ADDENDUM NO. 2
to the
PROJECT DOCUMENTS AND SPECIFICATIONS
for
T-HANGAR DEVELOPMENT

AVCON Project No. 2022.0241.01

Addendum Date: November 7, 2024

ADDENDUM NO. 2
T-HANGAR DEVELOPMENT
Calhoun County Airport

GRADING AND DRAINAGE PLAN

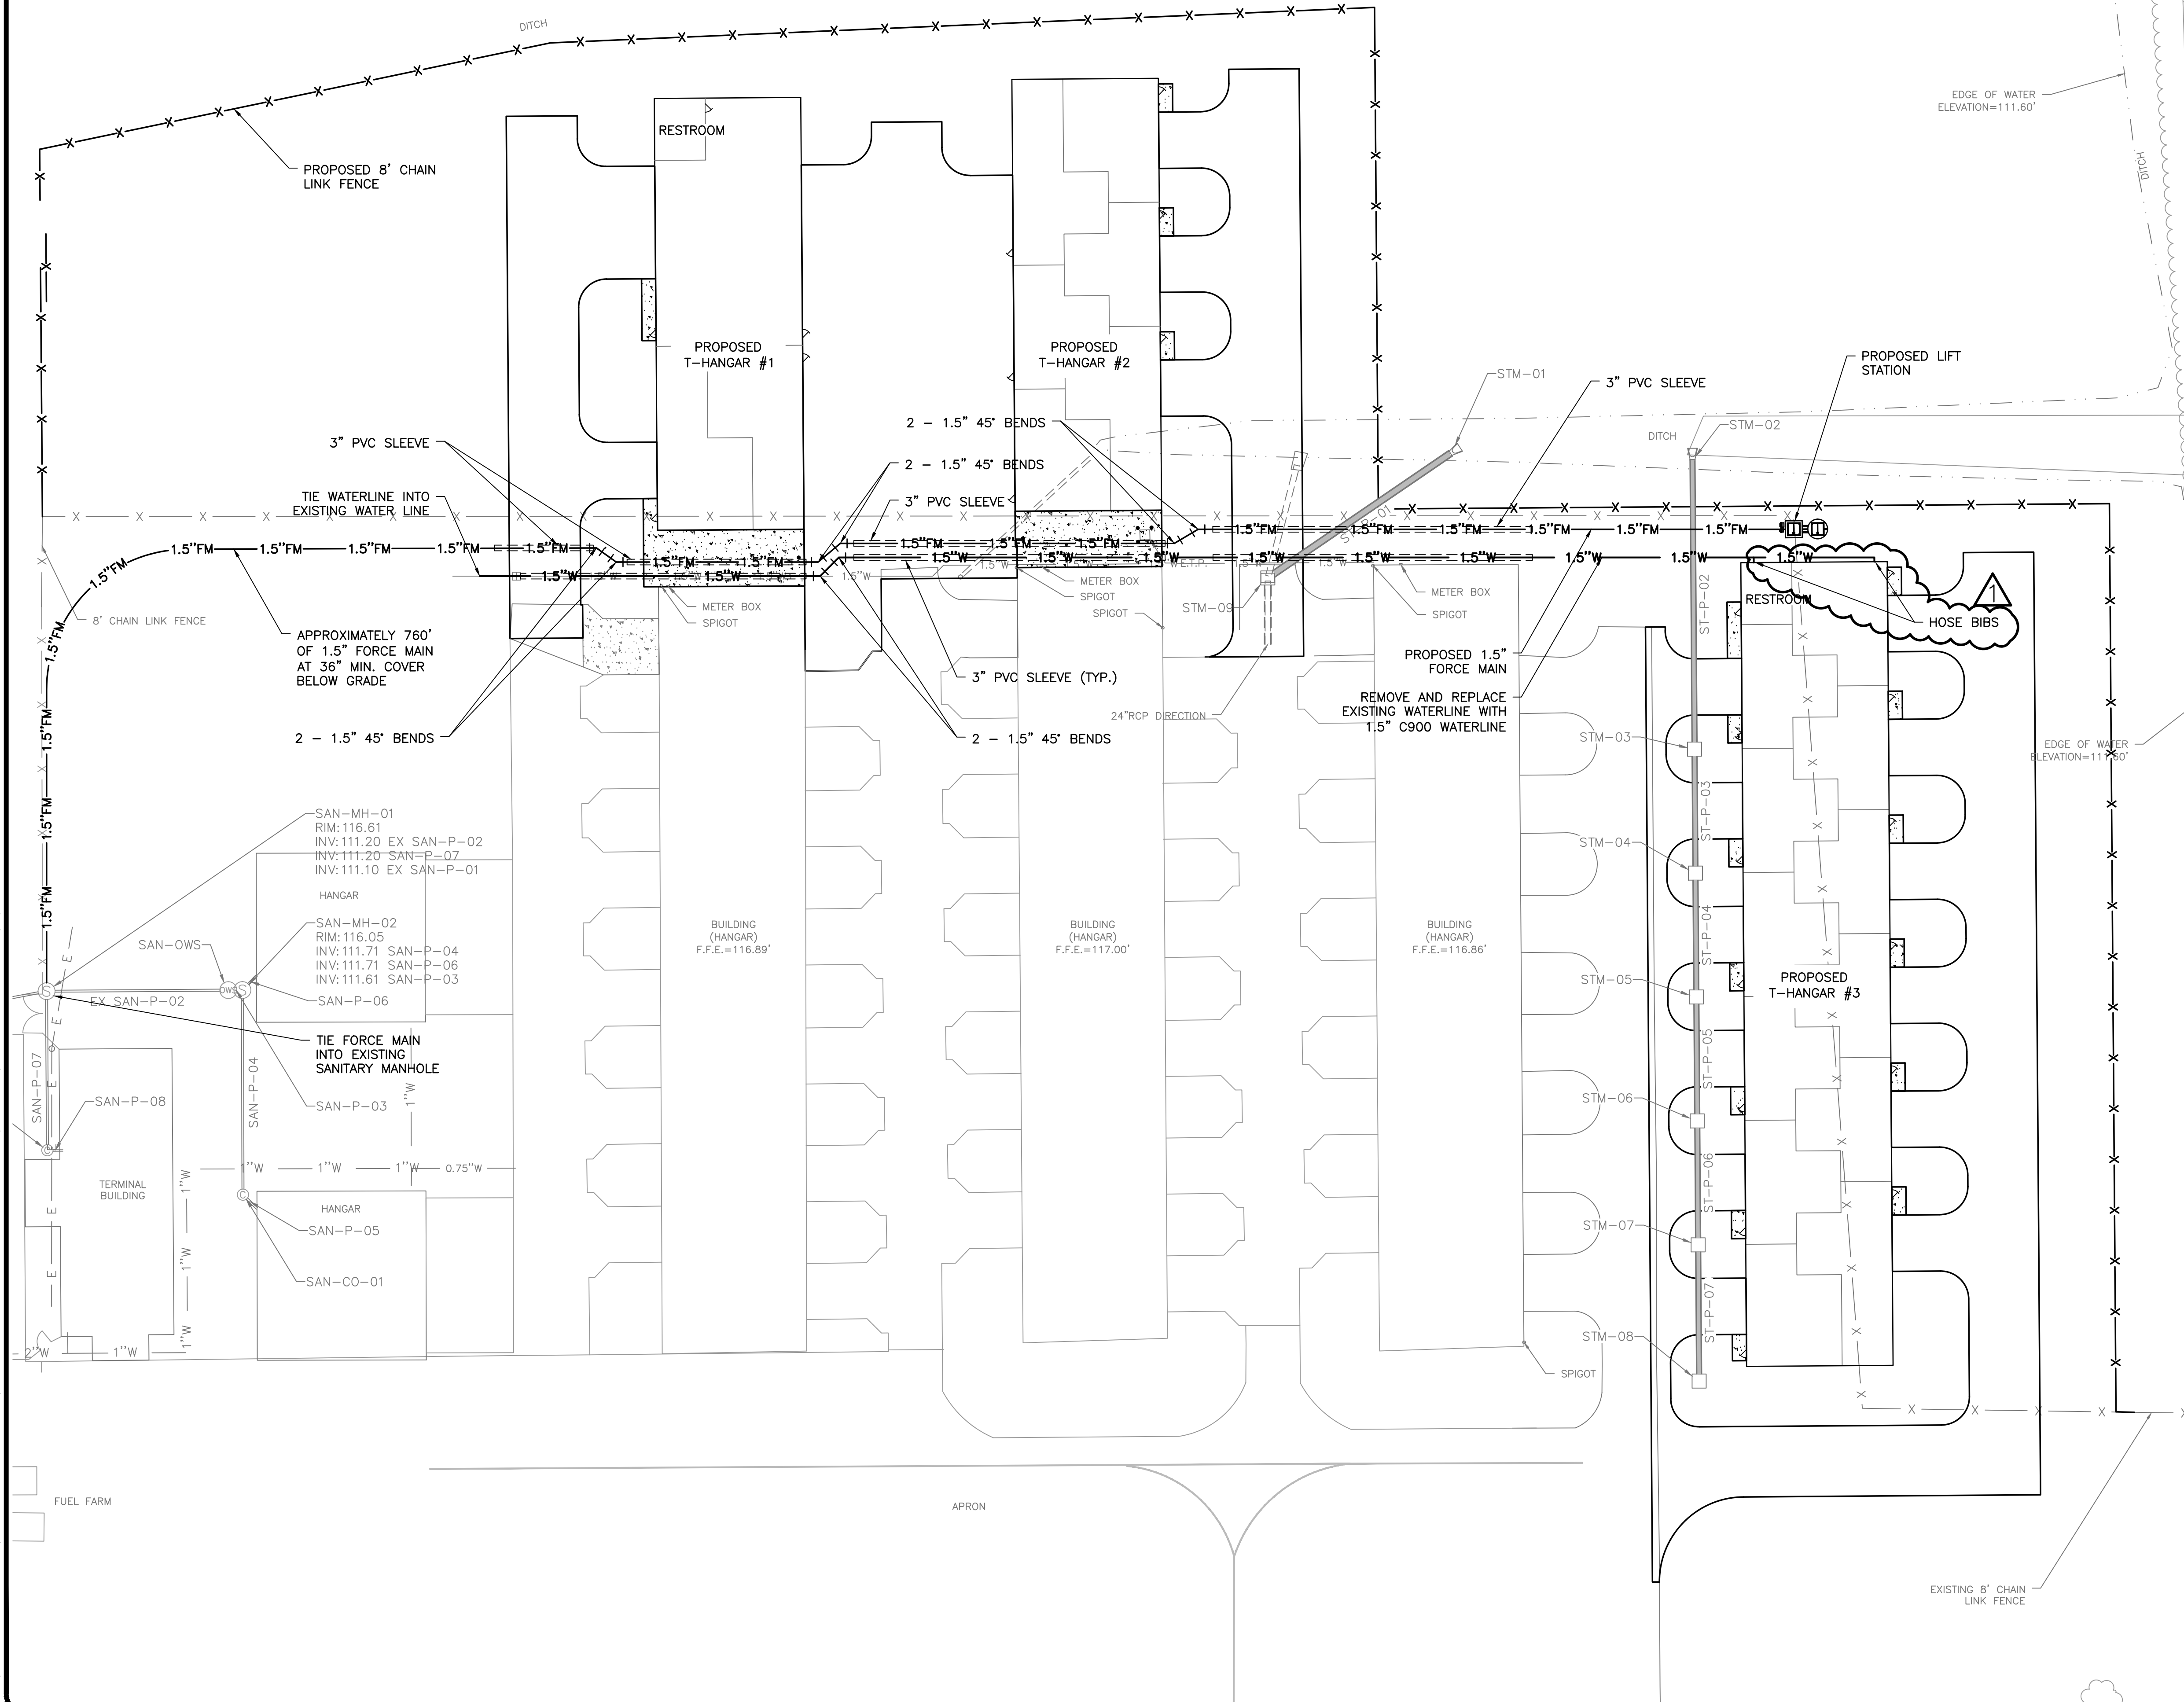
3. Lift Station: Can you please provide the proposed elevations for the Lift Station?

RESPONSE: The elevations are provided in Addendum No. 2.

T-HANGAR LAYOUT PLAN
 RELEASE FOR BID

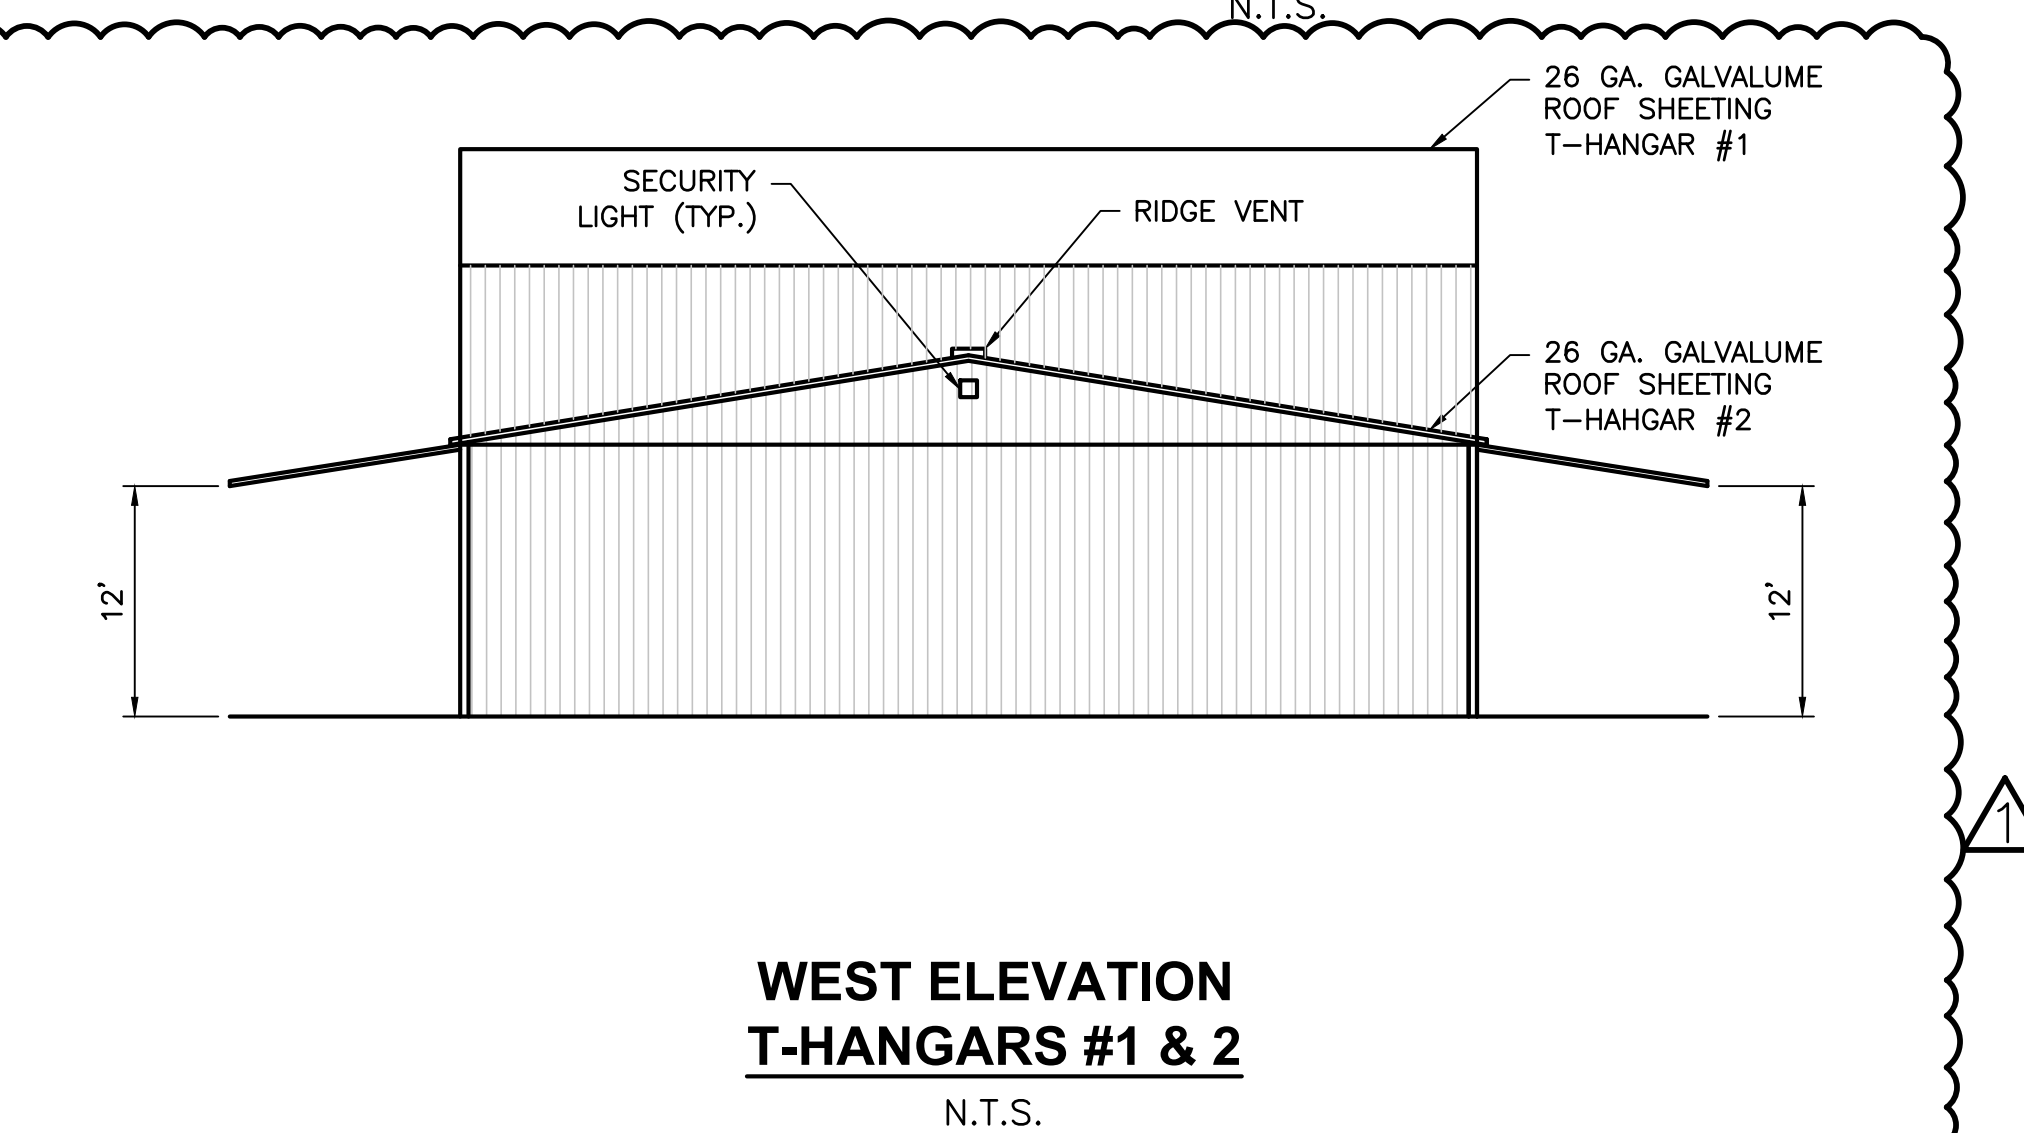
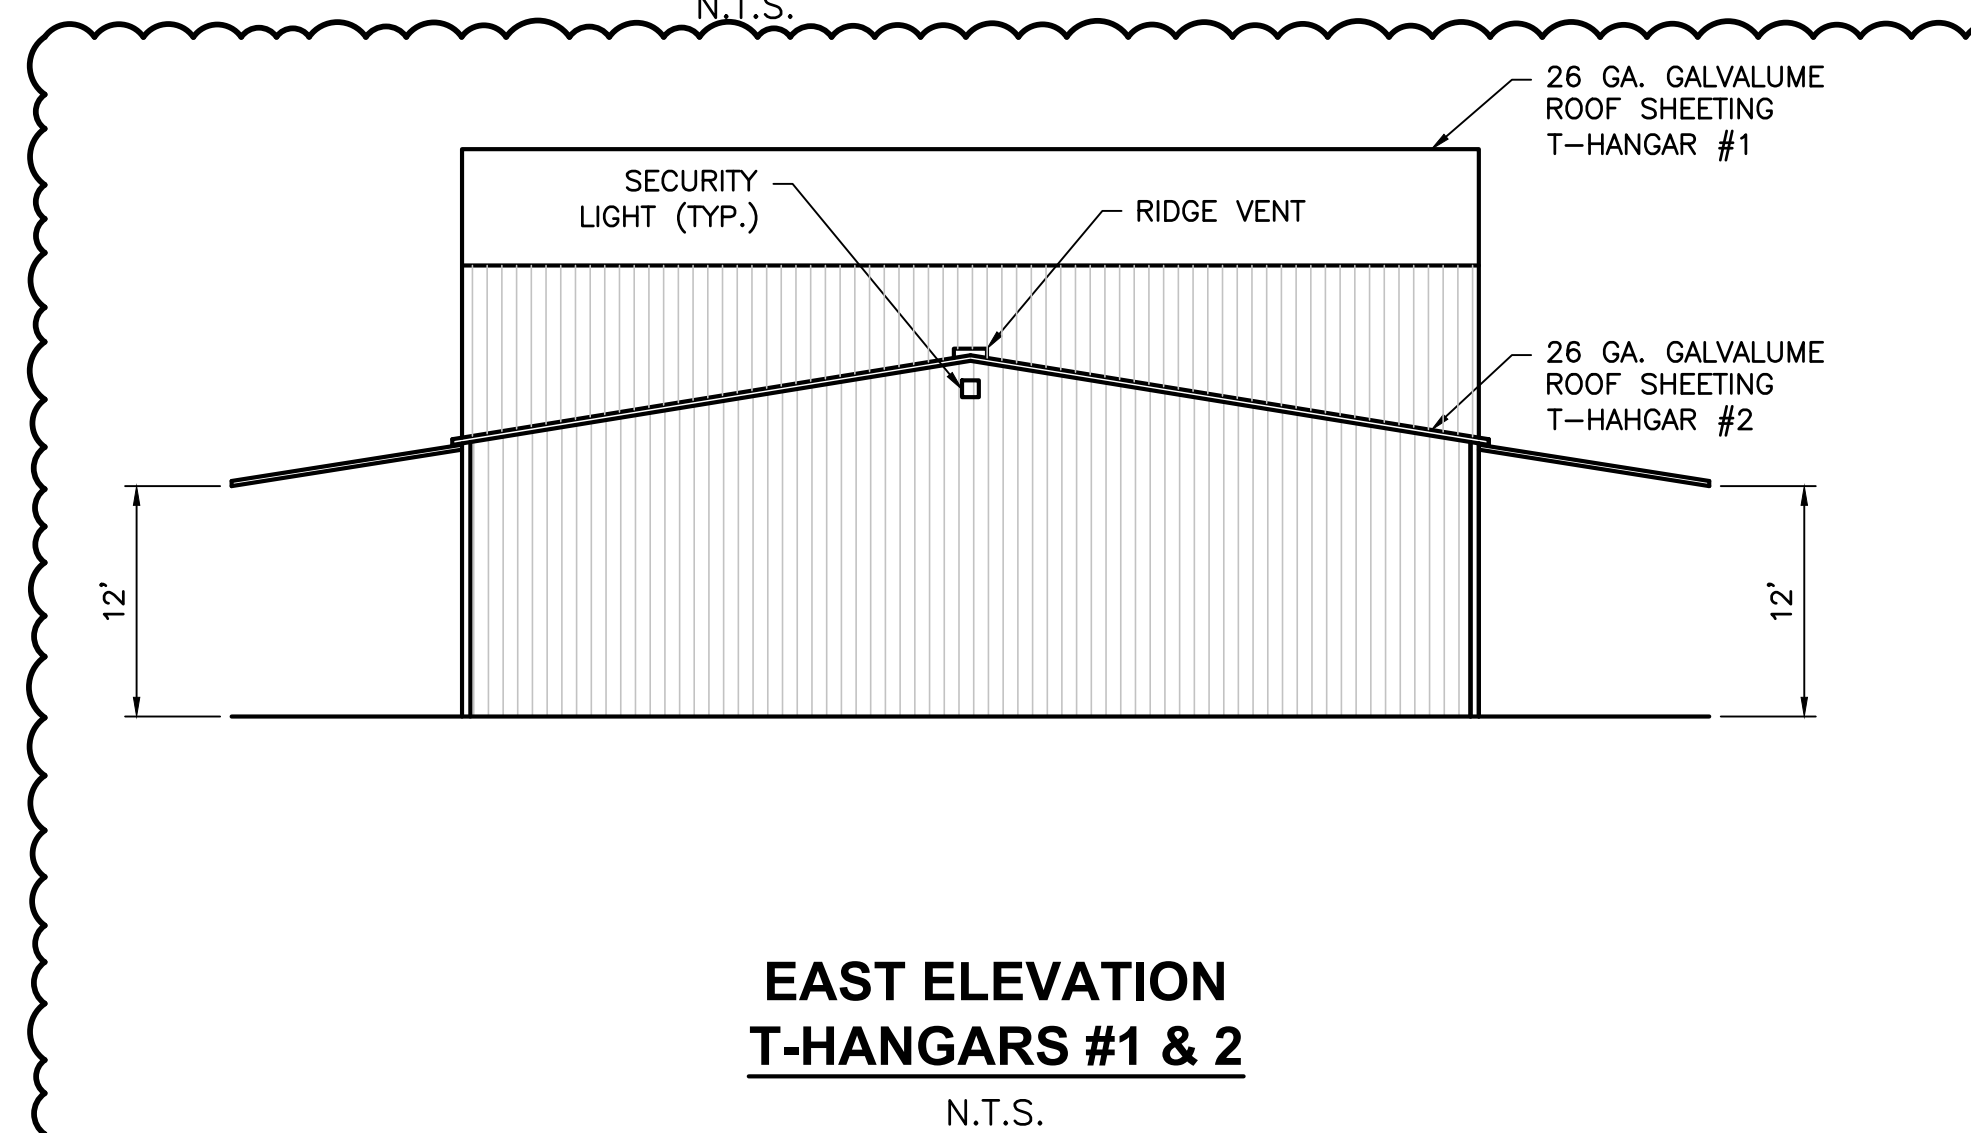
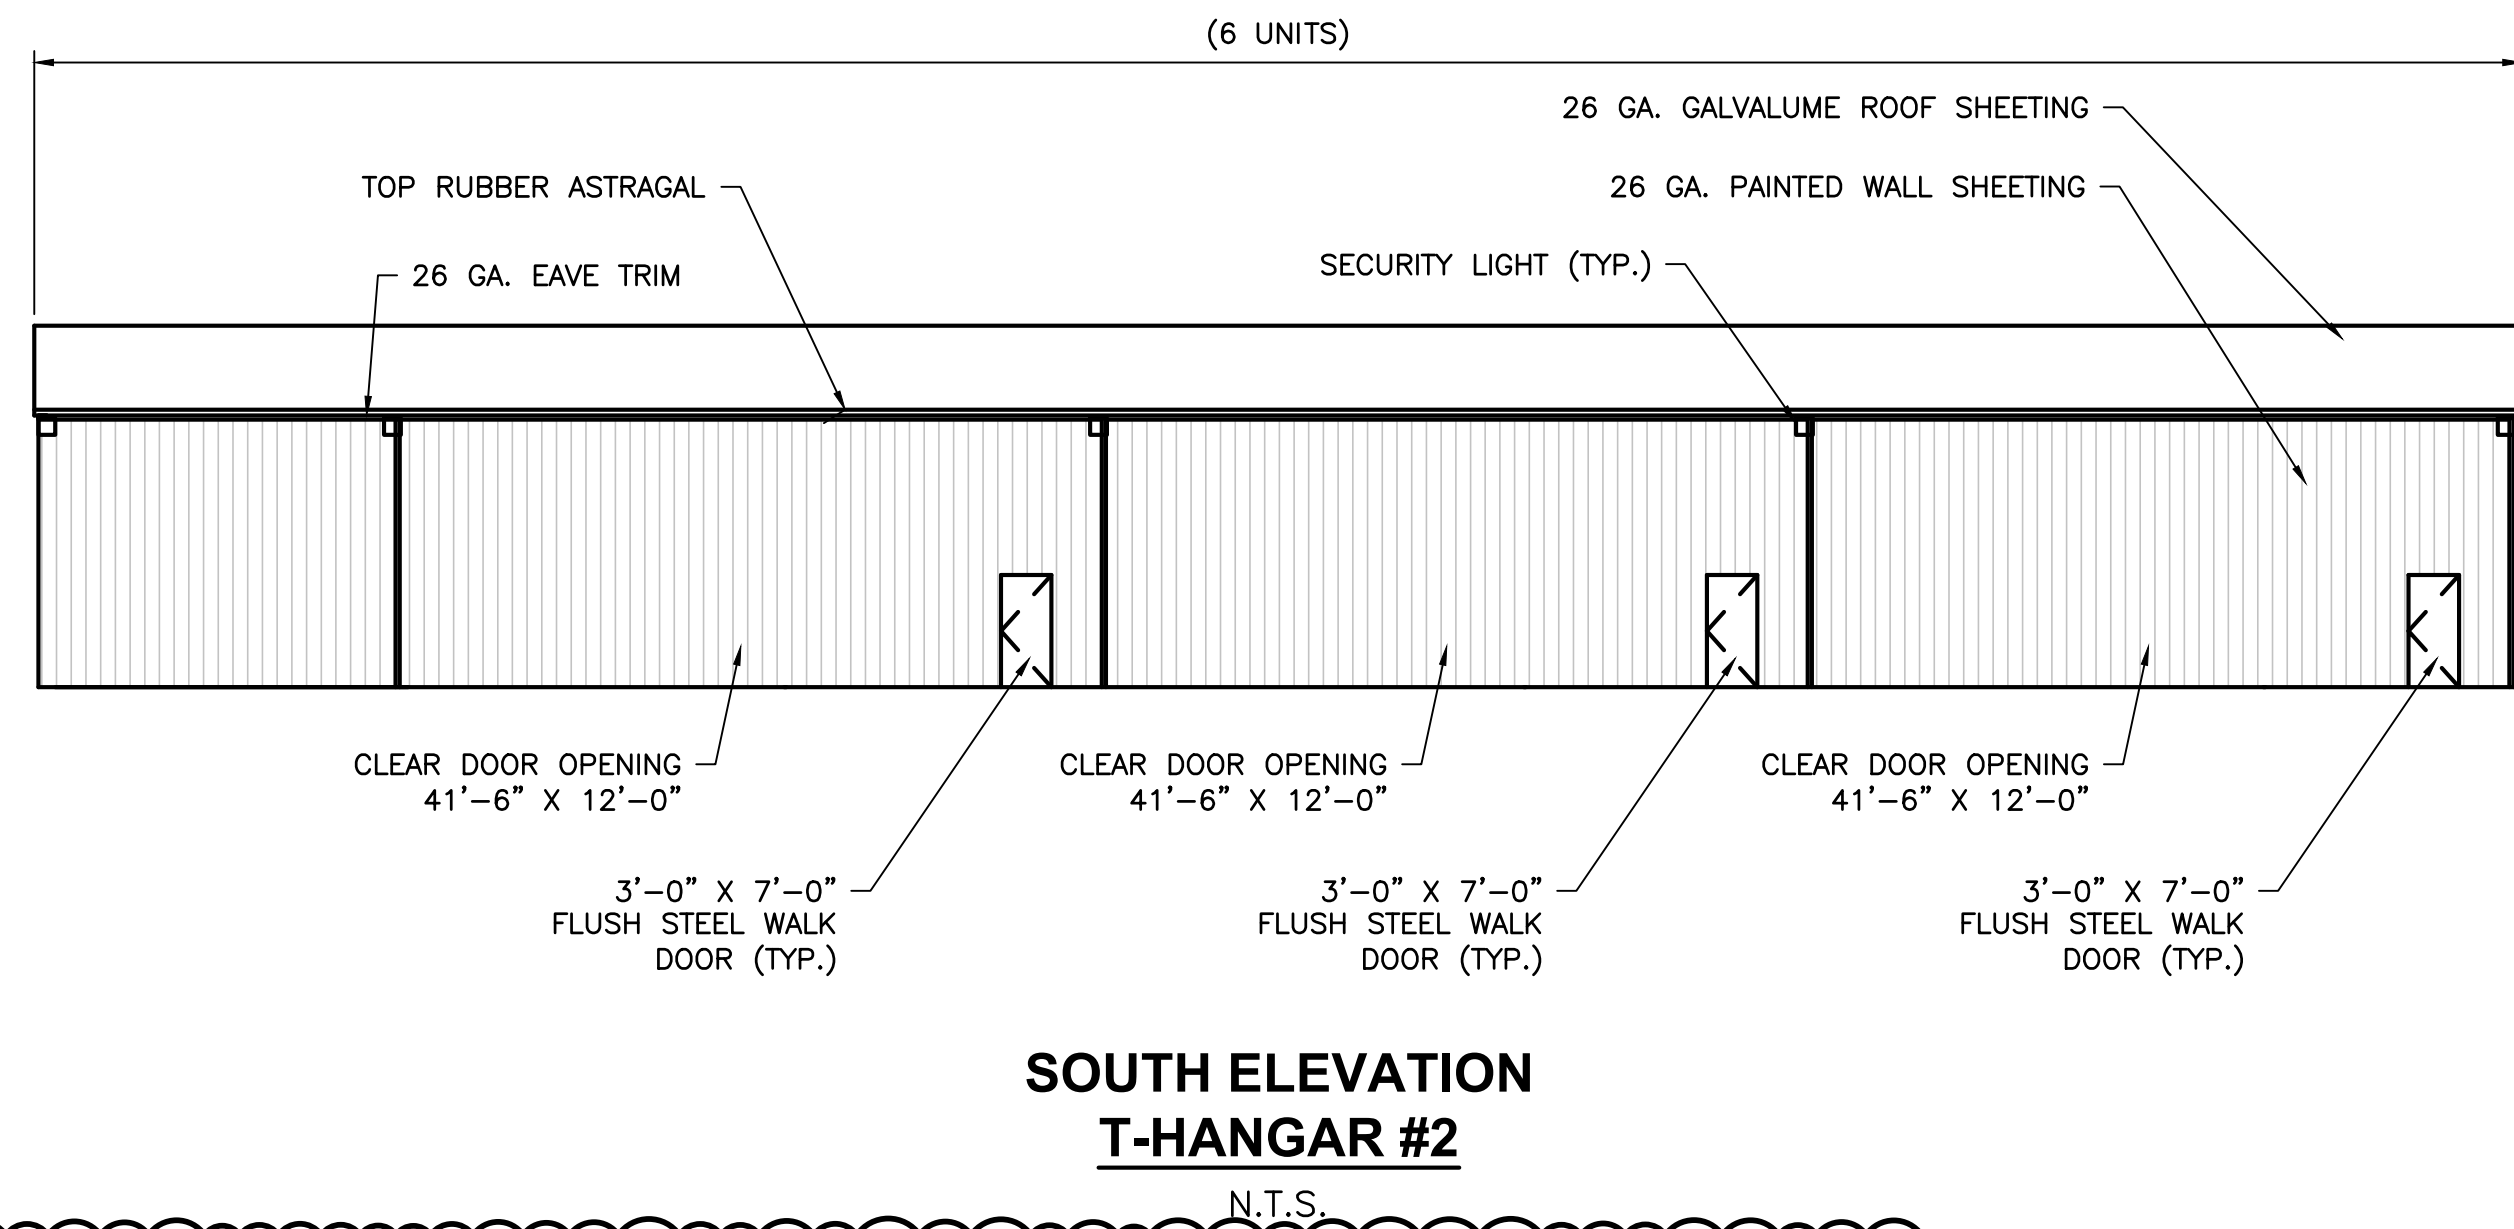
RESPONSE: Correct, the design of the T-Hangar foundations are the responsibility of the contractor per the requirements provided on Sheet C-6 and C-8 and Technical Specification H-100, Section 2.10(b). Addendum No. 2 clarifies that the minimum foundation slab thickness is 8 inches.

RESPONSE: The roof elevation and ridge orientation for the large open area in Hangar #1 have been revised in Addendum No. 2 to allow the load bearing walls to run north-south over the large open area. This should allow the clear open area depicted on Sheet C-6 without requiring interior columns. The tail section widths will be revised to 22 ft in Addendum No. 2.
